To: The NSW Department of Planning, Housing and Infrastructure
Re: Maules Creek Coal Mine Continuation Project, Application Number SSD-63428218

IEEFA has reviewed the Maules Creek Continuation Project Economic Assessment (Appendix K to the Environmental Impact Assessment) and found numerous problems with the proponent's thermal coal price forecasts, carbon cost assumptions and projected greenhouse gas emissions.

Figure 2: Australian thermal coal price forecasts, various sources

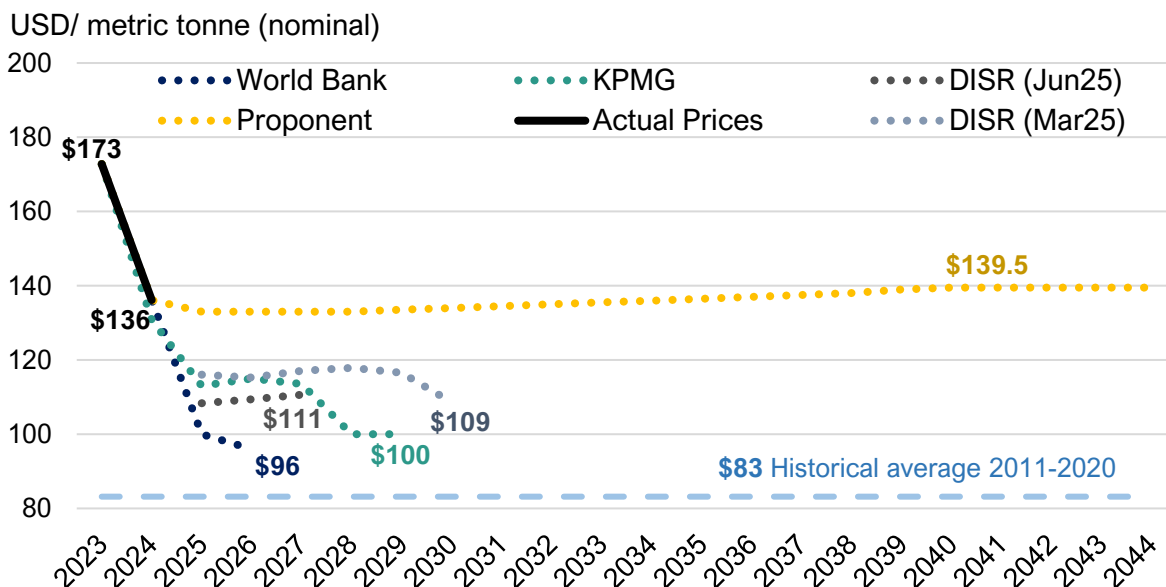
The thermal coal price forecasts in the Economic Assessment are significantly higher than other analysts forecasts, with no justification for the difference provided.

In the NSW technical notes that provide guidance on how and what to include in a project Economic Assessment it states, "The NSW Government preference is for market data to be used where it exists."^{8,9} However, the proponent has seemingly ignored multiple well-known sources for coal price forecasts in its own assumed thermal coal price forecast for the project.

The proponent has forecast a thermal coal price above USD132 per metric tonne in 2028, rising to USD139 per tonne through to 2044. According to the proponent's economic assessment, "These forecasts are based on consensus price forecasts that have been adjusted for ash and energy content by Whitehaven to derive realised coal prices for product coal from MCCM and from the Project."¹⁰ However, the proponent has not provided details on how a consensus price was calculated, or references to other existing price forecasts. The Australian government publishes price forecasts for thermal coal in its Resources and Energy Quarterly published by the Department of Industry, Science and Resources (DISR). Its most recent thermal coal price forecasts suggest thermal coal prices could achieve USD111 per tonne in 2027, 20% lower than the prices suggested by Whitehaven.

Figure 3: Difference between proponent's economic assessment thermal coal price forecasts and other agencies

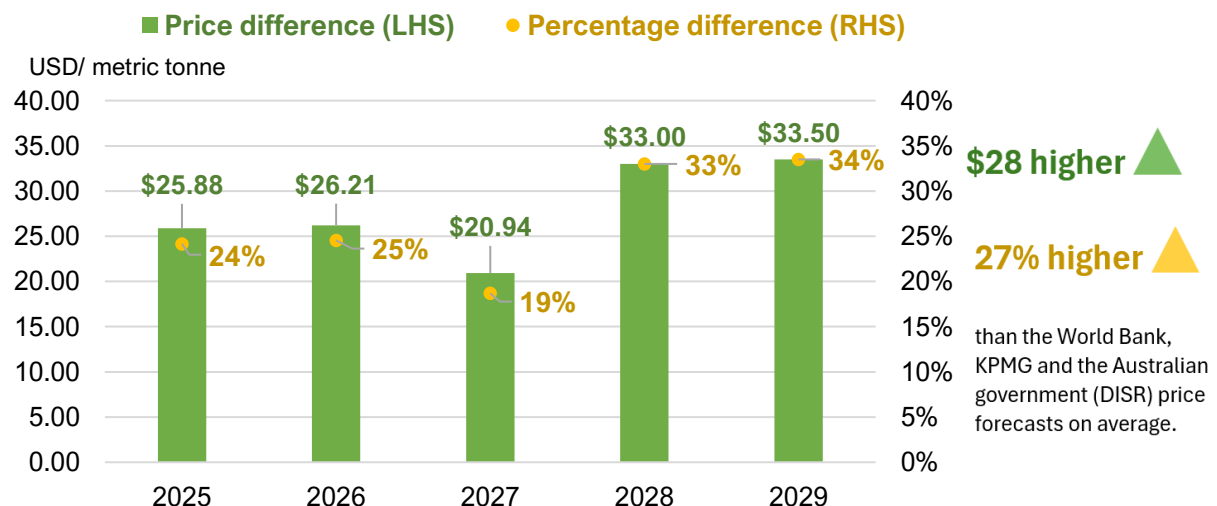
The proponent conducted a sensitivity analysis to its CBA by adjusting prices 20% lower than its own stated forecasts. However, the proponent's thermal coal forecasts are 27% higher on average between 2025 and 2029 than price forecasts produced by the World Bank, KPMG and the DISR. This means that the sensitivity analysis is insufficient to account for the variation between the proponent's price forecasts and those of other agencies, let alone account for the downside risks facing Australian thermal coal prices.

Figure 4: Seaborne global thermal coal trade 2025-2030, REQ vs IEA scenarios (Mt)

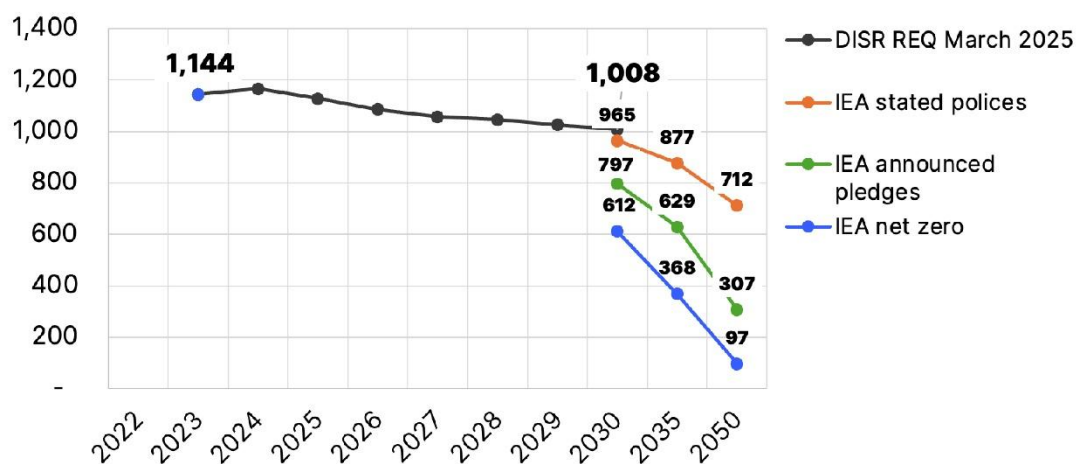
Additionally, the International Energy Agency (IEA)'s World Energy Outlook 2024 shows investment trends in coal-fired generation highlight coal's declining role in new electricity generation.¹⁸ The IEA also asserts that global thermal coal trade could decrease at faster rates than the DISR's projections under each of the agency's scenarios: Stated Policies, Announced Pledges and Net Zero.¹⁹

There are no equivalent replacement markets for Australia's high calorific value (CV) coal as Japan, South Korea and Taiwan phase out coal-fired power. And there is no evidence to suggest import demand growth in South-east Asia won't be met by cheaper thermal coal suppliers such as Indonesia, South Africa, Russia or Colombia.

Figure 6: Projected Australian Carbon Credit Unit prices, AUD

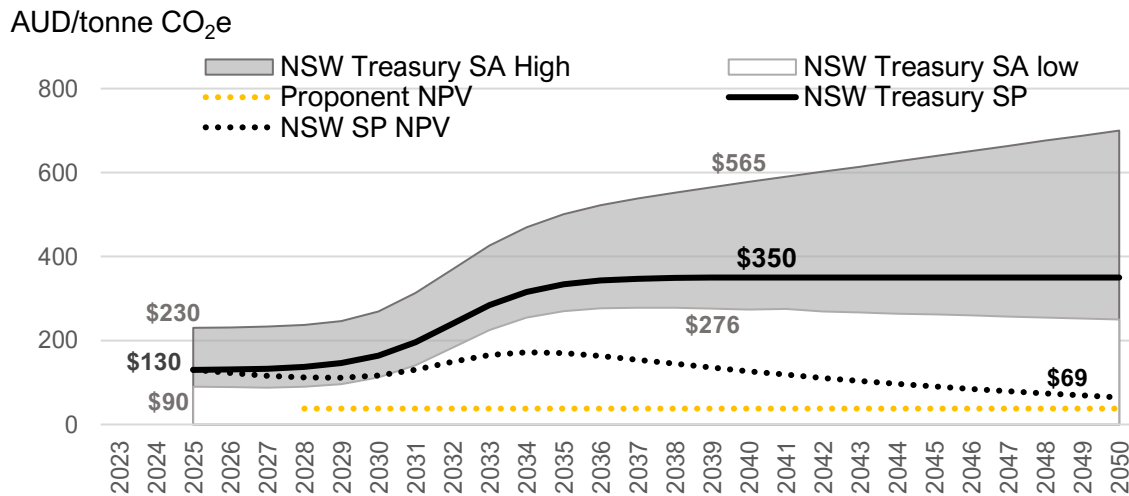
NSW Treasury published carbon shadow prices in December 2024 that have not been used by the proponent in its economic assessment and CBA. NSW Treasury states a carbon price of AUD130 per tonne (rising to AUD350 per tonne in 2024 dollar terms by 2040) must be used when valuing carbon emission impacts in cost-benefit analysis (CBA), noting that “These values must be applied in CBAs submitted after January 2025 and replace those in Technical Note – Carbon Value in Cost-Benefit Analysis.”²⁰

The proponent states that it would “purchase ACCUs [Australian Carbon Credit Units] to offset Scope 1 GHG emissions above the Safeguard Mechanism baseline under the (National Greenhouse and Energy Reporting) NGER Act”.²¹ The proponent estimates an additional cost of AUD53 million, in NPV terms, to be generated by the project as a result of the valuation of these Safeguard Mechanism carbon liabilities. The proponent has stated an emissions liability of 1.4Mt of CO₂e over the life of the project. This would assume the proponent has estimated an average carbon cost of AUD\$37.86 per tonne of CO₂e between FY2028 and FY2054 in the CBA, in NPV terms. It is not clear if it assumes a constant cost per year or a lower cost in 2028 that increases through to 2054.

Regardless, applying the NSW Treasury shadow carbon price instead would **generate over AUD274 million in carbon costs, in NPV terms.**²² **This is over five times (AUD221 million) higher** than currently estimated by the proponent in its CBA. Additionally, methane emissions from the project are higher than currently estimated – these costs could become significantly higher.

Figure 7: BHP's forecast Australian Carbon Credit Unit price, USD

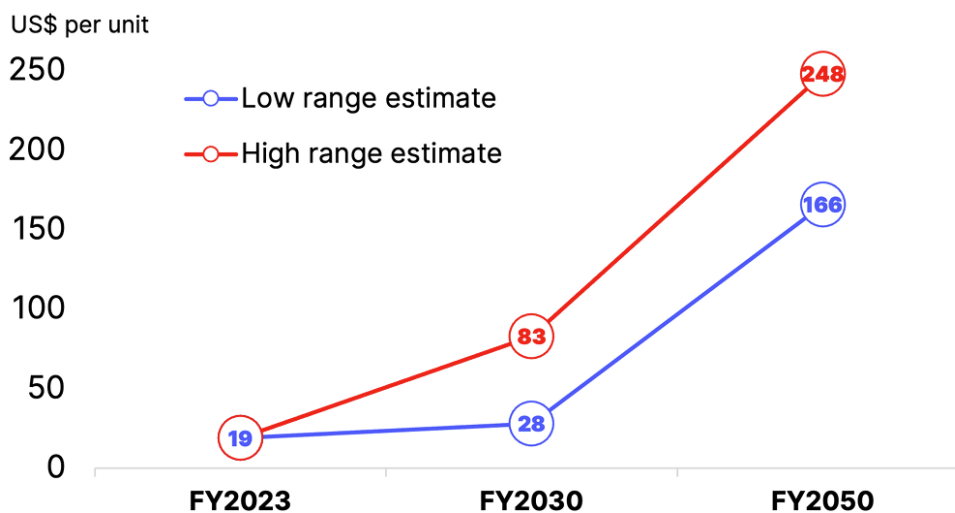
The estimated carbon cost prices used by the proponent are also much lower than price estimates from other coal mining companies in Australia, such as BHP.

Figure 8: Estimates of methane emissions underreporting from Australian coal mining and oil & gas

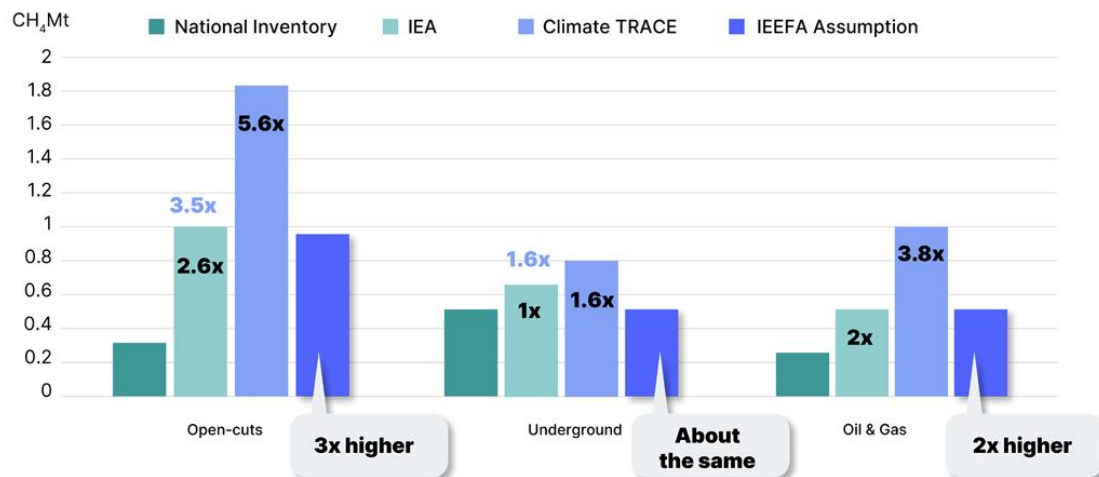
A growing body of evidence has found that reported methane estimates from open-cut coal mines in Australia could be more than twice as high as currently reported. The Australian government has stated that the uncertainty in methane emissions reporting by open-cut mines is at least 30%.²⁶ Additionally, analysis from the Superpower Institute suggests methane emissions from the fossil fuel sector could be twice as high as what is reported²⁷; and data from the IEA

suggests open-cut coal mine emissions could be three times higher on average than currently reported²⁸.

The uncertainty of estimated methane emissions from the project should be accounted for in the sensitivity analysis of the CBA and ultimately reflected in the uncertainty on NPV of the total carbon cost of the project. **The NPV of carbon costs from the project can vary based on the uncertainty surrounding the total GHG emissions from the project and the uncertainty of the cost of ACCUs or Safeguard Mechanism Credits (SMCs) necessary to offset these emissions under the Safeguard Mechanism.**

Figure 9: Method 2 actual reported methane emissions intensity vs Method 1 standards

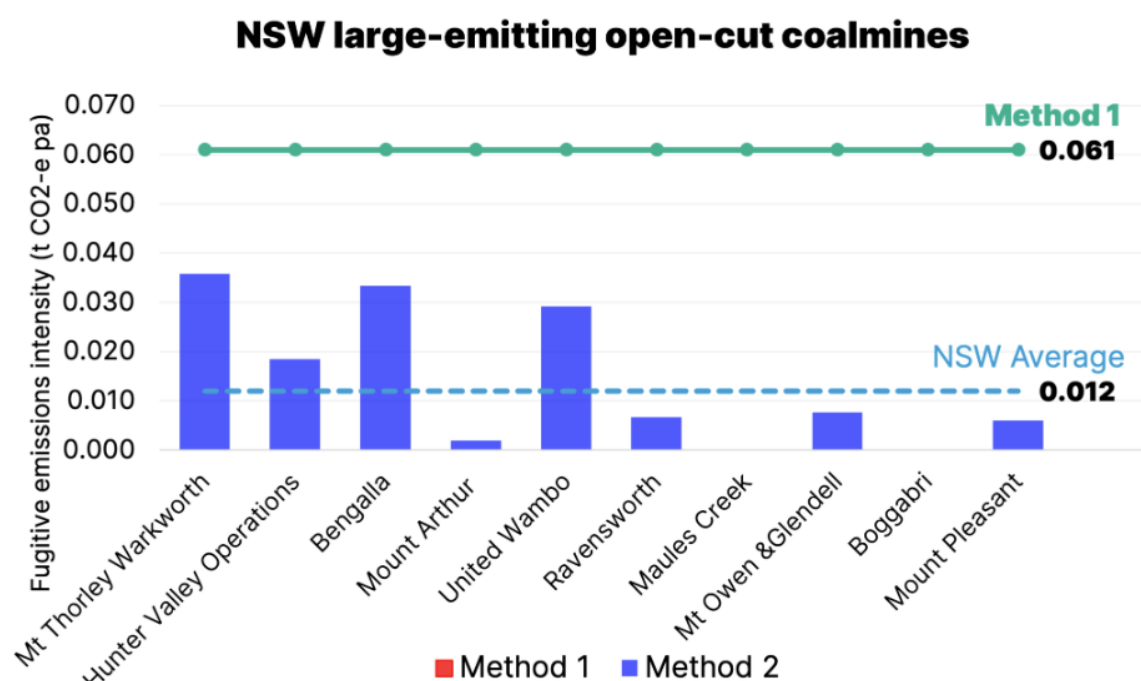
Recently, all open-cut coal mines in NSW, including Maules Creek, moved from using Method 1 to Method 2 under the NGER Scheme to estimate methane emissions from coal mining. After switching to using Method 2, total reported Scope 1 emissions from Maule’s Creek decreased by 60%.³⁰ There is potential that total scope 1 emissions would have decreased during this period due to decreased production or mining less gassy seams or decreasing carbon dioxide

emissions. However, when examining data from other large NSW open cut coal mines, the reported methane emissions per unit of coal produced were 80% lower under Method 2 estimations compared with Method 1 default factors, based on the FY2023-24 Safeguard Facility data.³¹ This means that the decrease in reported emissions would not be driven by a decrease in production.

The Australian Climate Change Authority reviewed the Methods in the NGER scheme and recommended, “as a matter of urgency, review Method 2 with respect to sampling requirements and standards”.³² Additionally, research from the University of Wollongong has found the Method 2 approach to determining “low-gas zones” flawed.³³ This is due to the standards containing an artificially high gas detection threshold and an associated low amount of gas assumed for the low-gas zone, effectively underreporting gas considerably. This is most pronounced when high levels of methane are found in the gas (due to gas density differences). The study recommended lowering the threshold gas factor used in Method 2 by an order of magnitude.
